SUBJECT: Coastside Design Review Continuance
Cedar Street, Montara
APN 036-132-210; County File No. PLN 2019-00362

At its meeting of October 14, 2021, the San Mateo County Coastside Design Review Committee (CDRC) considered your application for a Design Review Permit to allow a 2,450 sq. ft., 2-story, single-family residence with an attached two-car, 480 sq. ft. garage on a legal 6,975 sq. ft. undeveloped parcel (PLN 2016-00222), associated with a staff-level Resource Management (RM) Permit, Coastal Development Permit (CDP) and a Variance to allow for 10 foot front and side setbacks, and a 12 foot rear setback, where a 50 foot front yard setback and 20 foot rear and side yard setbacks are required, due to the triangular shape of the parcel. The project includes minor grading and the proposed removal of 10 significant trees. The project is not appealable to the California Coastal Commission. In light of concerns expressed by the neighbor to the south and as discussed at the meeting, the applicant will consult with Planning staff regarding the requested Variance(s) for front side and rear setbacks. CDRC has suggested that although the triangular shape of the parcel is challenging, t

LANDSCAPE PLAN

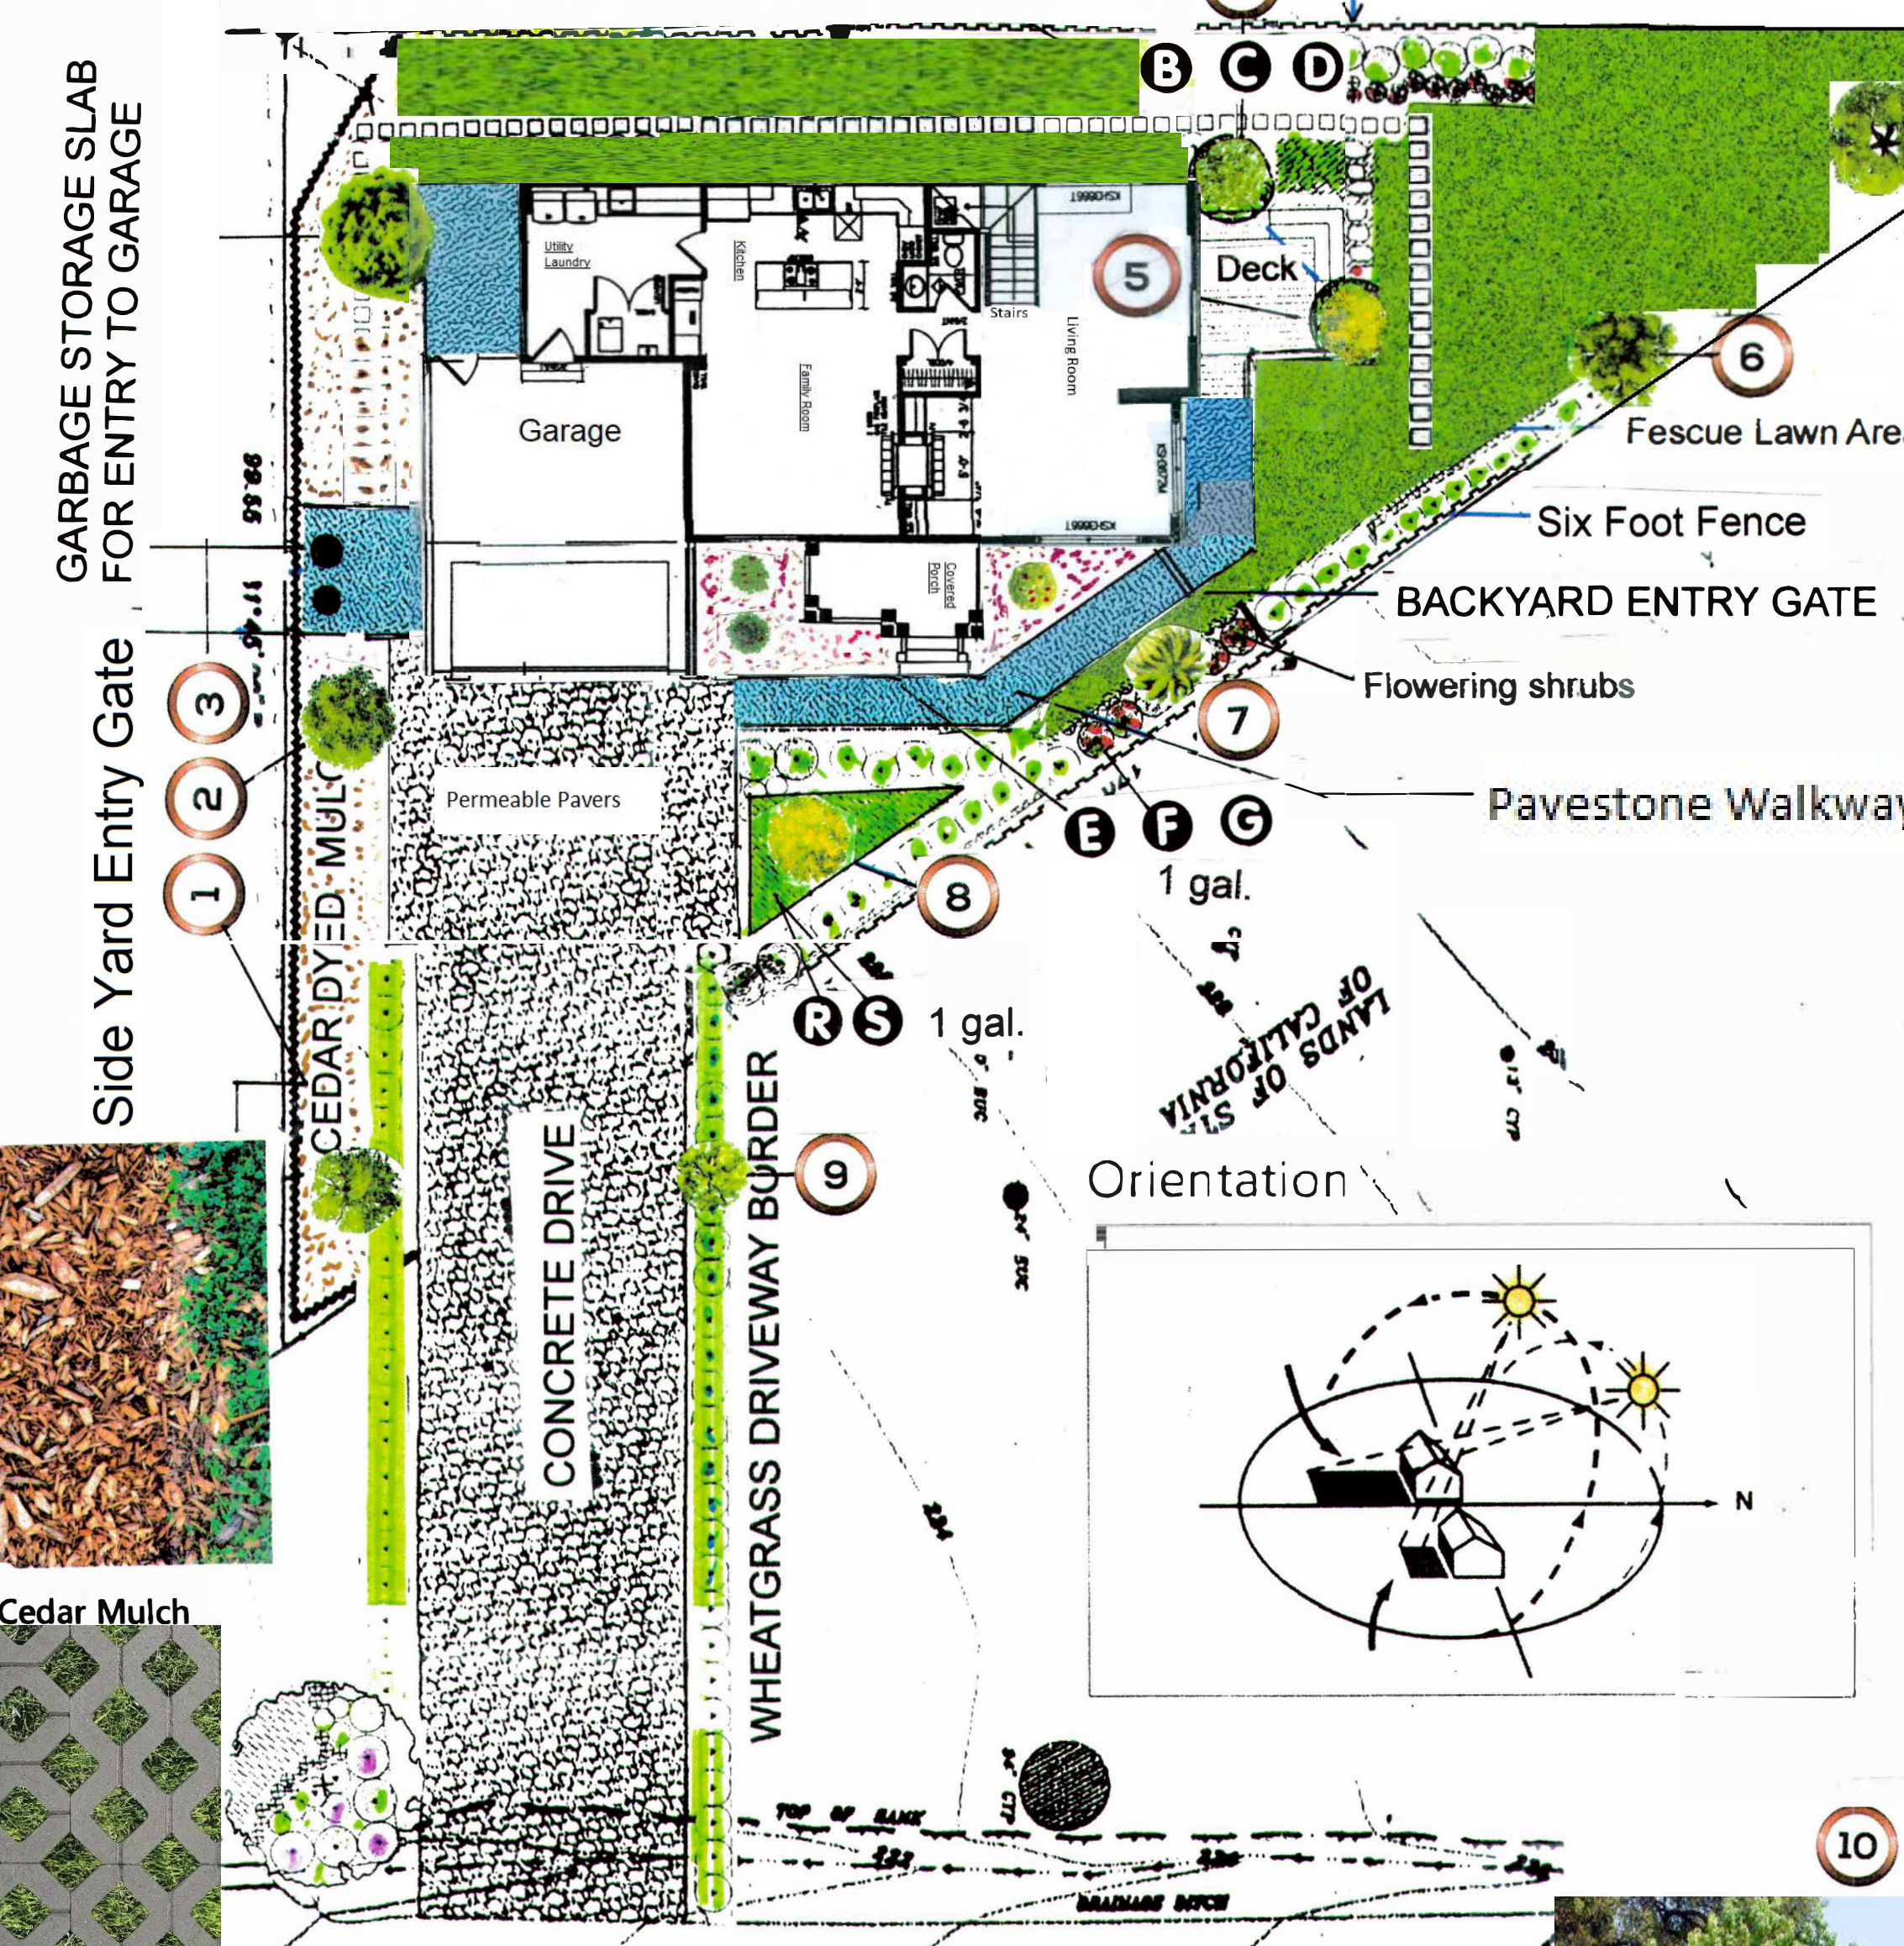
Arborist Note from 2018 The proposed water service line is very close to trees #10 and #12, within the lands of the state of California. If these two trees cannot be removed, the line should be moved at least 10 feet away from these two trees to keep impacts low. Excavation at the proposed distance could potentially have a high impact on tree stability and health. The proposed water line is also in close proximity to large cypress tree #2. If possible the water hook up should be at least 18 feet from cypress tree #2. The water line will need to be excavated with the use of an air knife in combination with hand tools when within 36 feet of cypress tree #2. No roots within 18 feet of this tree shall be cut. The line shall be tunneled underneath and between roots when possible to reduce impacts to the trees. This work shall be supervised by the Project Arborist. Impacts are expected to be minor if the above recommendations are followed.

Note: As per the recommendation of the Arborist's original observation regarding Trees #1 and #2, the lateral service lines have been moved. There is approximately 50 feet between trees #1 and #2. Service lines are now 27 feet away from tree #1 and 24 Feet away from tree #2. Service lines are now greater than 10 feet away from trees # 10 -12. As such, installation should have minimal impact.
